TECHNICAL BULLETIN

PRODUCT: CONDENSFIT FLUES

FLUES INTENDED FOR USE WITH CONDENSING GAS & OIL APPLIANCES.

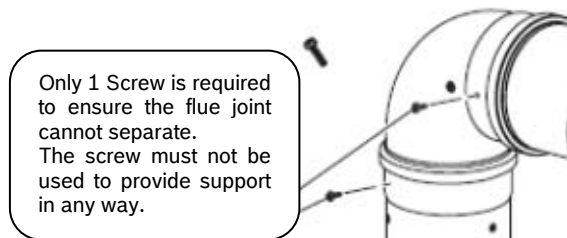
Every flue joint must be retained with a screw which is supplied with the flue accessory.

Historically our literature may have referred to one or two screws in each joint; likewise we may have supplied one or two screws with each flue extension or elbow.

Whenever possible, guidance in the manuals should be followed. Screws should be fitted 180° apart on the flue connection, however we recognise that some installations may make it difficult to access the joint sufficiently to fit two screws. On these rare occasions we would deem one screw to be acceptable.

Where only one screw is used, it must be in a visible position for inspection purposes.

Whenever a flue is identified to have only one screw in each joint, providing the flue is correctly supported and the screw is only being used for its intended purpose to prevent the joint from separating due to external influences, then the flue should not be deemed "Not to Current Standards".
